Project Name	BCWD Permit 24-06 2024 Rutherford Elementary Site Improvements	Date	05/03/2024
To / Contact info	BCWD Board of Managers		
Cc / Contact info	TJ Rose; Larson Engineering, Mitch Honsa; Larson Engineering, Tony Willger; Stillwater School District		
Cc / Contact info	Karen Kill, Administrator / BCWD		
From / Contact info	Paul Nation, PE; John Sarafolean / EOR		
Regarding	Permit Application No. 24-06 Engineer's Report

Review based on BCWD Rules effective April 1, 2020

Recommendation: Consider variance request and otherwise Approve with Conditions

Figure 1: Site Plan

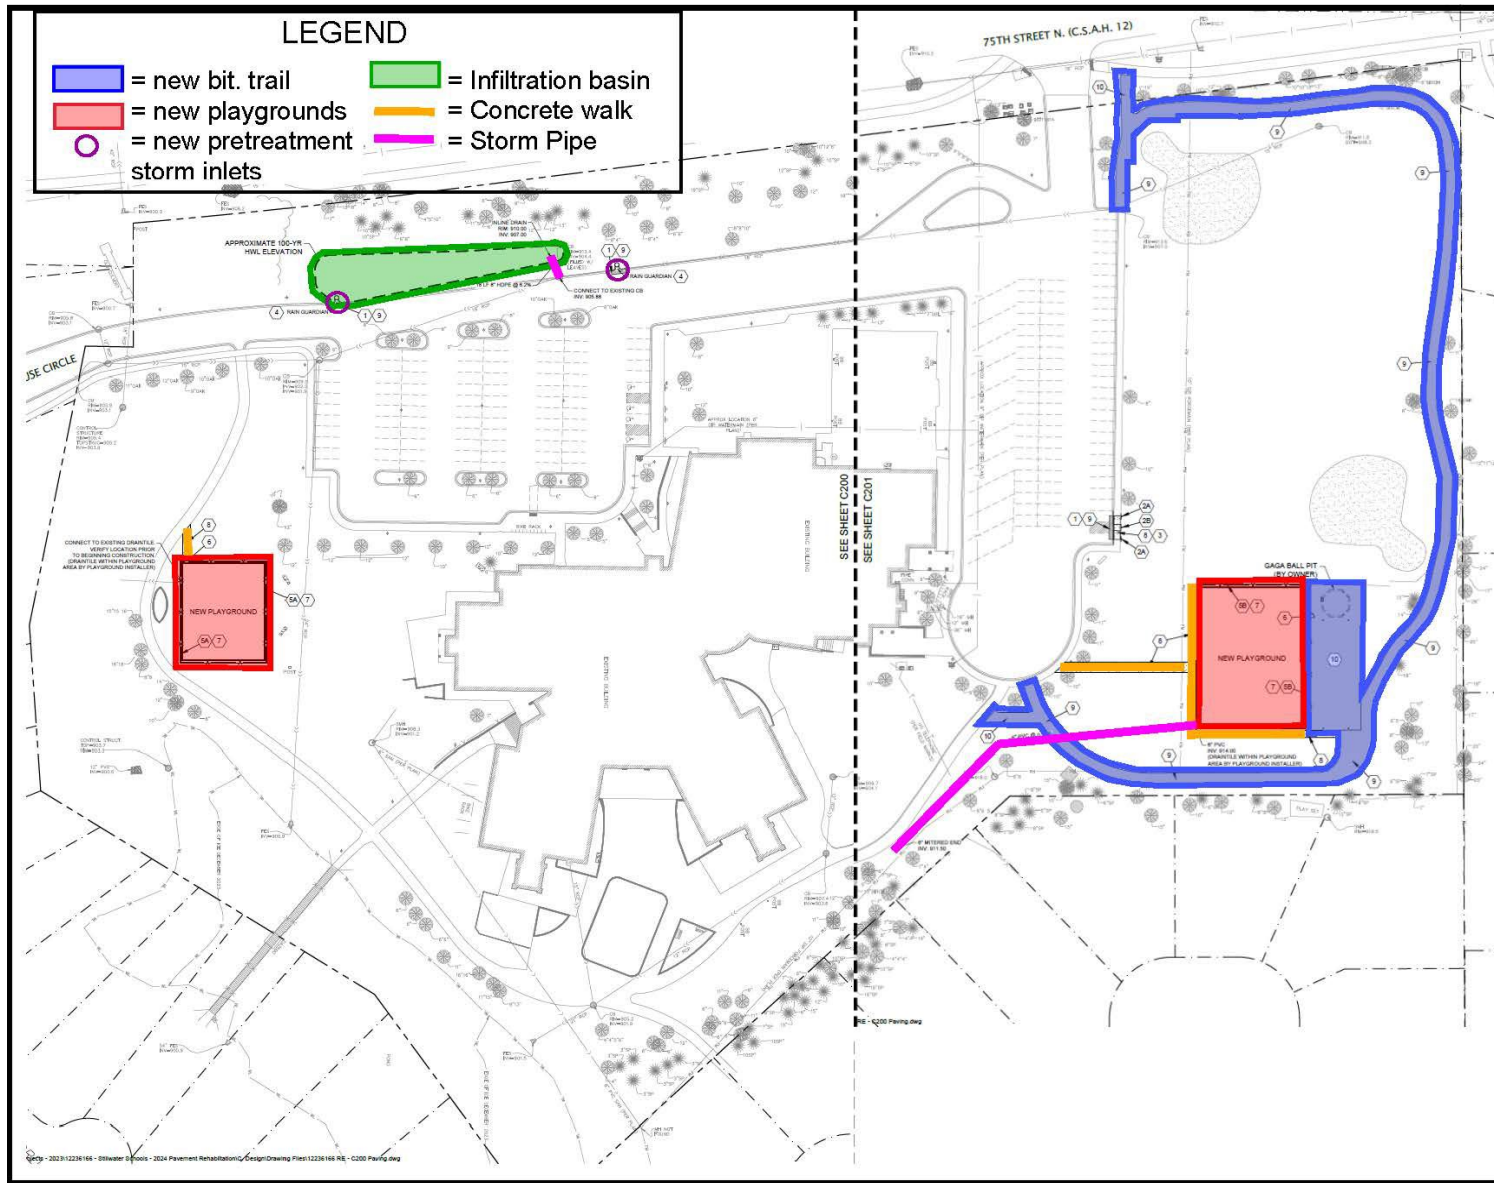
The applicant proposes site improvements to the existing Rutherford Elementary school in Stillwater. The project site includes the 16.1-acre Rutherford Elementary parcel and the adjacent 2.7-acre Washington County parcel to the north shown in Figure 1. The Washington county parcel is included because of the land-disturbing activities to connect the Rutherford Elementary and Washington county trail systems. The total site area is 18.8 acres.

Figure 2: Existing site drainage.

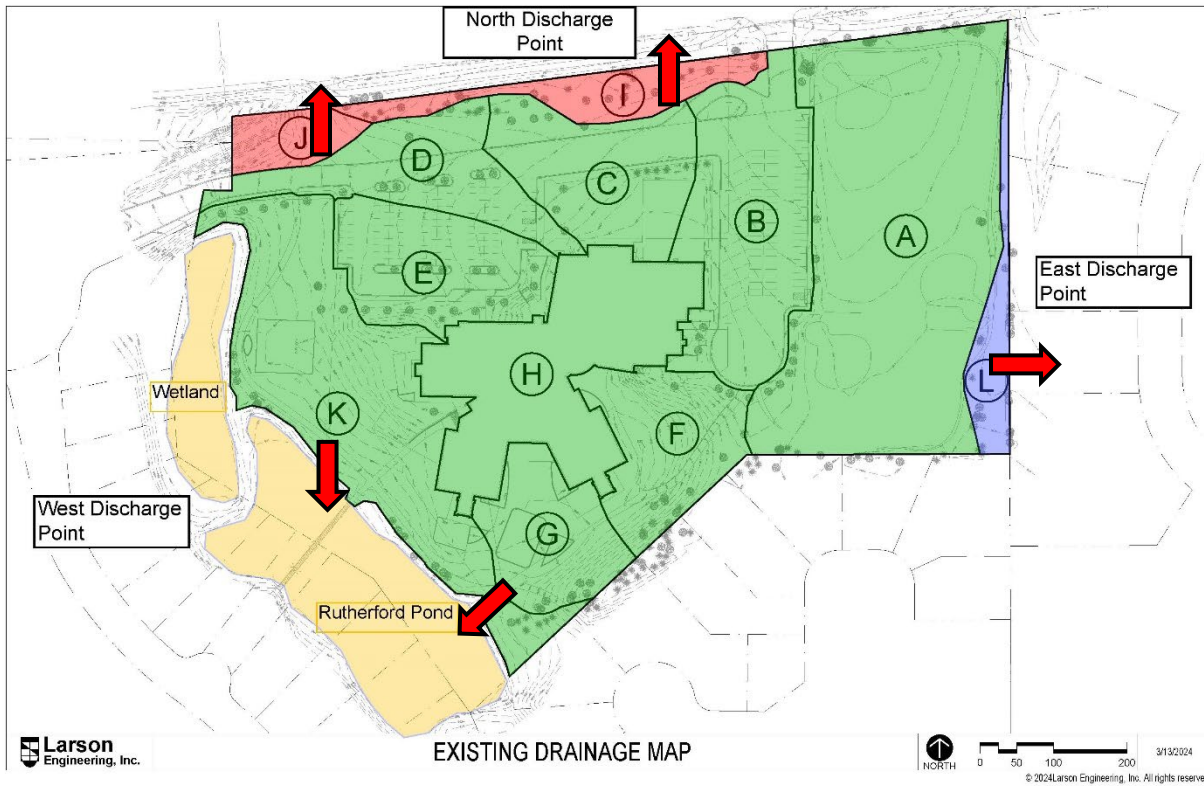
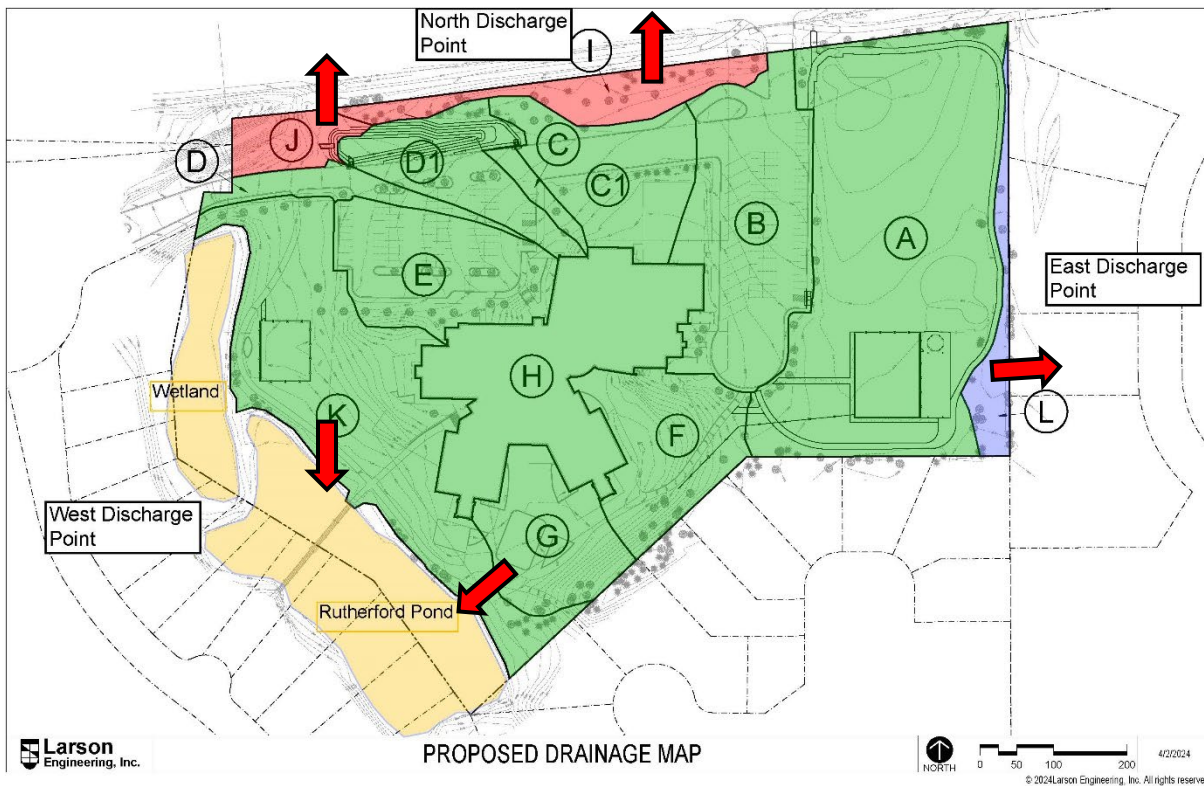
The existing drainage of the project site consists of three discharge points: north, east, and west. Two drainage areas on the north side of the site totaling 0.78 acres in size drain overland to the north discharge point through turf grass and a wooded area into the ditch along 75th St. N. then travel from the ditch by culvert to a 0.67-acre wetland located at the northwest corner of the site. The east discharge point is fed by one drainage area that is 0.33 acres in size. The stormwater runoff sheet flows over turf grass discharging onto the adjacent property to the east. The west discharge point consists of an existing stormwater retention basin, Rutherford Pond, that was constructed with the initial construction of Rutherford Elementary and a 0.67-acre wetland immediately to the north. The west discharge point is fed by nine drainage areas on site totaling 13.4 acres in size. Stormwater runoff to the west runs overland through turf grass directly to the pond and wetland, and sheet flows over turf grass and impervious surfaces into existing storm sewer discharging into Rutherford Pond.

Under proposed conditions, drainage to the east discharge point will remain the same. Stormwater discharge to the north will be reduced with the construction of the infiltration basin but continuing to overland sheet flow through the turf grass and wooded areas. The Stormwater discharge to the west will decrease due to runoff diverting from flowing in existing storm sewer to Rutherford Pond to the infiltration basin, the mechanisms of reaching the discharge point will remain the same. All the new and reconstructed impervious surfaces on the site are within drainage areas that drain to the west discharge point.
